# Product Change Notification

**Change Notification #:** 115264 - 00  
**Change Title:** Intel® Server System R2208WTTYC1R, PCN 116264 – 00, Product Design, Removing Screw from PCIe Riser Bracket Top Cover  
**Date of Publication:** January 23, 2017

Figure 1. PCIe\* Riser Bracket

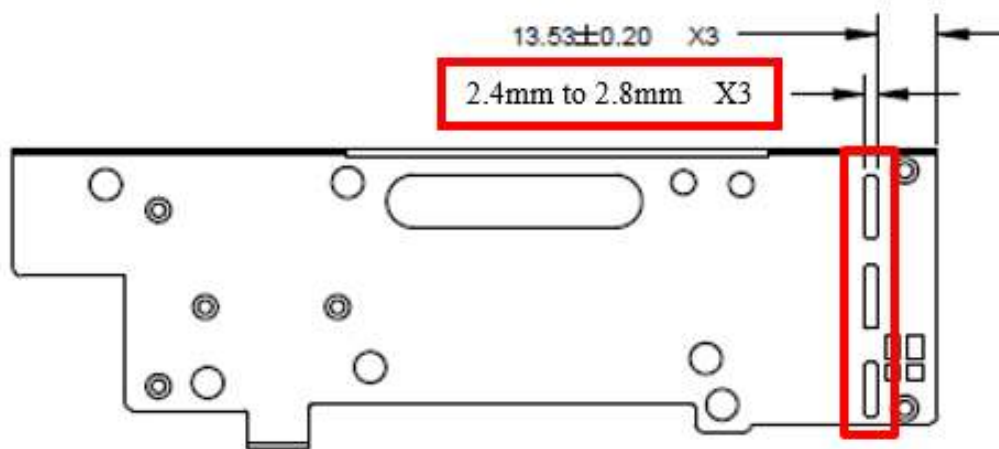
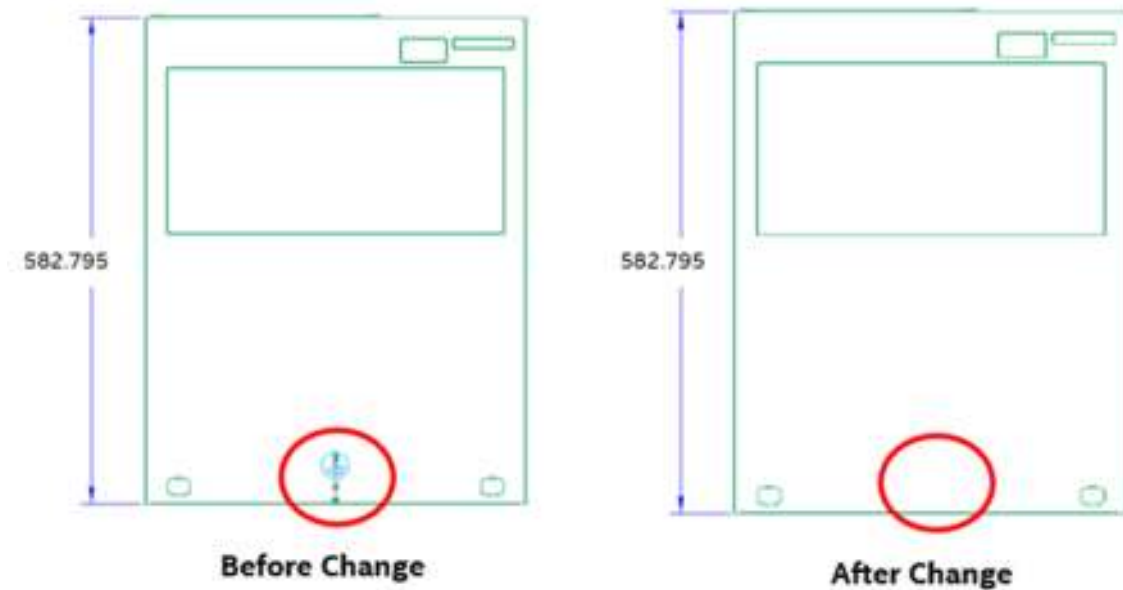
1. The width of the holes in the PCIe\* Riser bracket will change from 2.4mm to 2.8mm.
